PRELIMINARY REPORT

Dam Safety Assessment of CCW Impoundments

GenOn Energy – Shawville Generating Station Shawville, Clearfield County, Pennsylvania

December 17, 2012

FIGURE 4

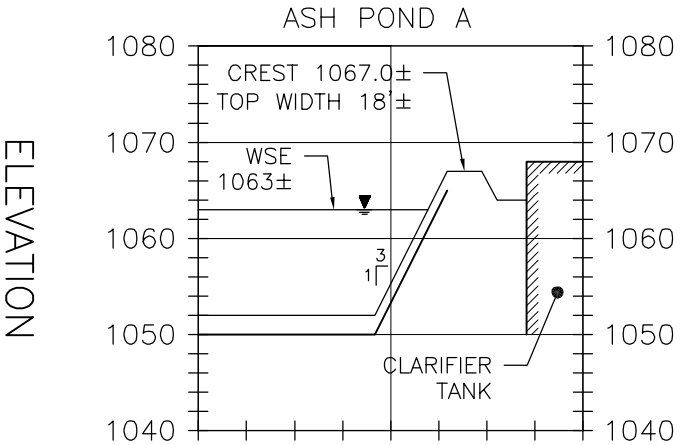
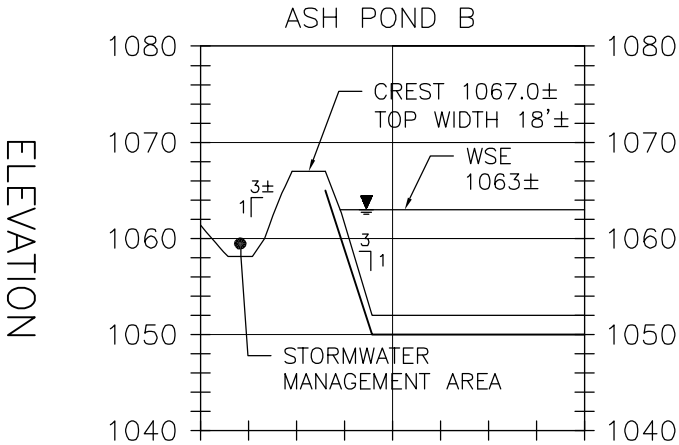
In addition to the physical deficiencies, we also noted that no geotechnical data or associated slope stability analyses are on record for the impoundment. Typical cross-sections of the impoundment are provided in Figures 3 and 4. The embankments are generally broad-crested with typical crest widths varying between 18 and 24 feet with relatively flat side slopes (3:1 or flatter). The presence of a constructed liner significantly reduces the risk of developing a phreatic surface within the diked embankment. The data provided for Monitoring Wells MW-9 and MW-10 indicate that the groundwater elevation within the northwestern embankment adjacent to the West Branch of the Susquehanna River is typically below the bottom elevation of the Ash Ponds, indicative that the liner system is serving to prevent the development of a phreatic surface within this embankment. Given the nature of this impoundment as primarily incised with a constructed impermeable liner system, there do not appear to be any critical slopes requiring a stability analysis in the immediate future. Completion of a slope stability analysis should be considered if modifications to the impoundment structure or significant alterations in the normal water level are proposed in the future.
